Alert Service Bulletin No. 069

200F, 201F, 202F Fuel Pump Leak Inspection and Diaphragm Replacement

Figure 1 - 200F & 202F Identification

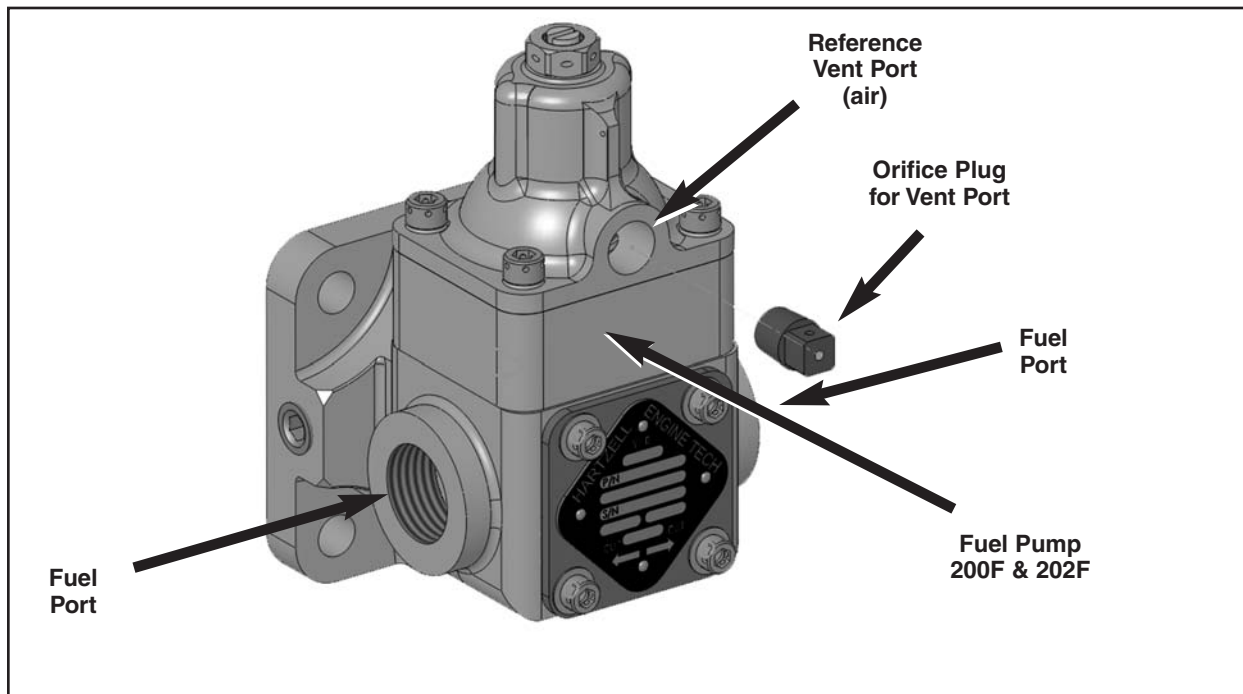
- (a) Inspection of the orifice plug requires only a visual inspection. Look around the plug and into the orifice for fuel or blue dye stains. Refer to Fig. 1 or Fig. 2.

Figure 4 - Typical Cooling Shroud Installation

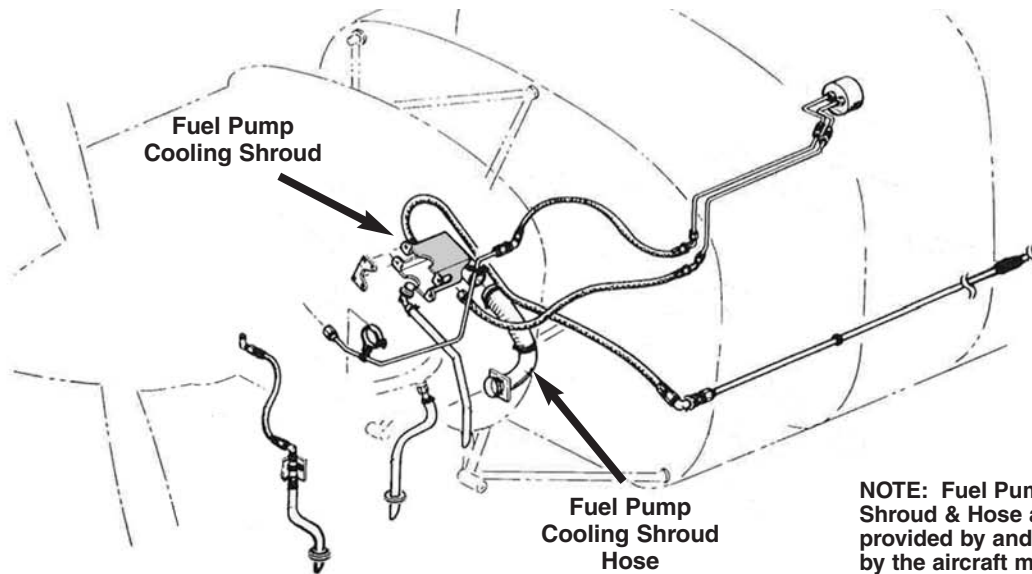
- (a) Reassemble the connection for the upper deck reference or the engine turbocharger reference lines.
 - (b) If removed, reinstall the fuel pump cooling shroud and air hose (if applicable) in accordance with latest engine/airframe service instructions or maintenance manual and continue to “Return to Service” 3.D.(1). Refer to Fig. 4.

Figure 5 - Typical HET 201F Fuel Pump Plumbed to Upper Deck Reference

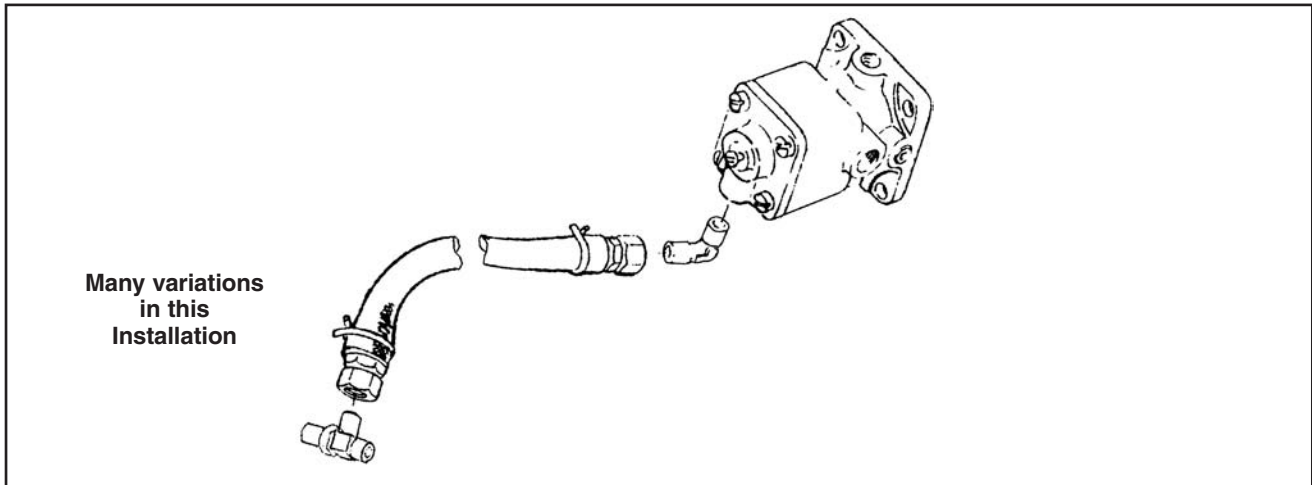
- (b) Inspection of the upper deck reference line requires that the line be disconnected and the inside of the fitting be inspected for fuel or blue dye stains. Refer to Fig. 5 and 6.

Figure 6 - Typical HET 201F Fuel Pump Turbocharger Reference Line Connection

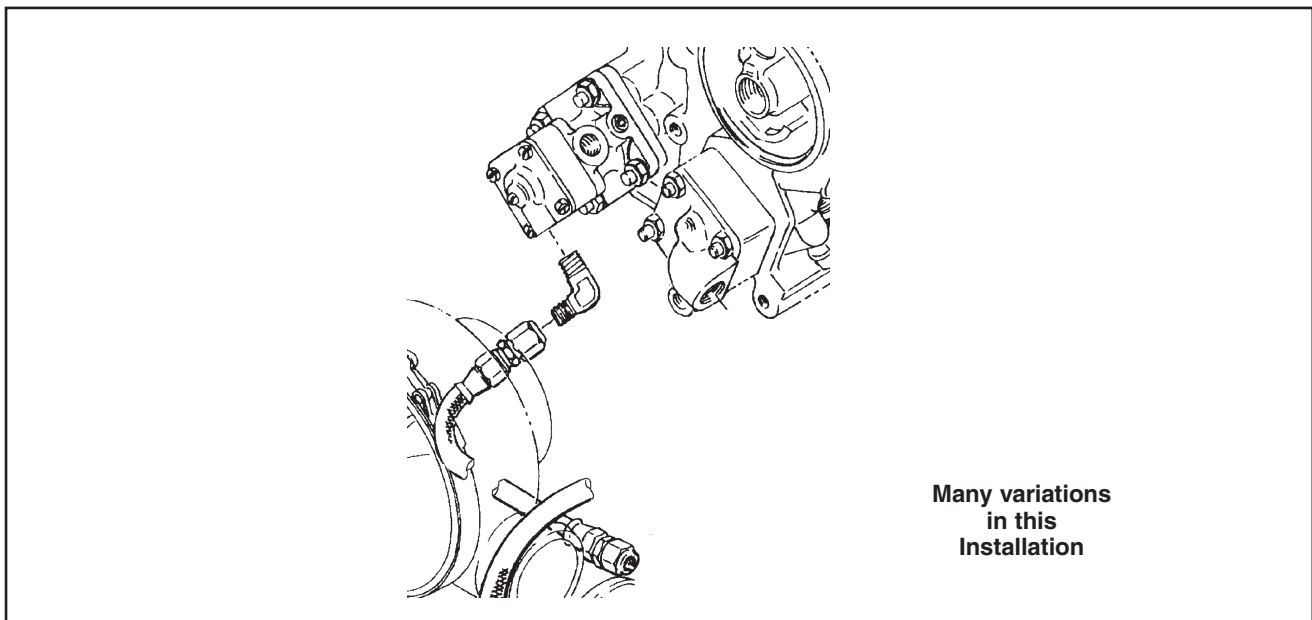
- (c) Inspection of the engine turbocharger reference line will require that the “B” nut be removed and the inside of the fitting be inspected for fuel or blue dye stains.
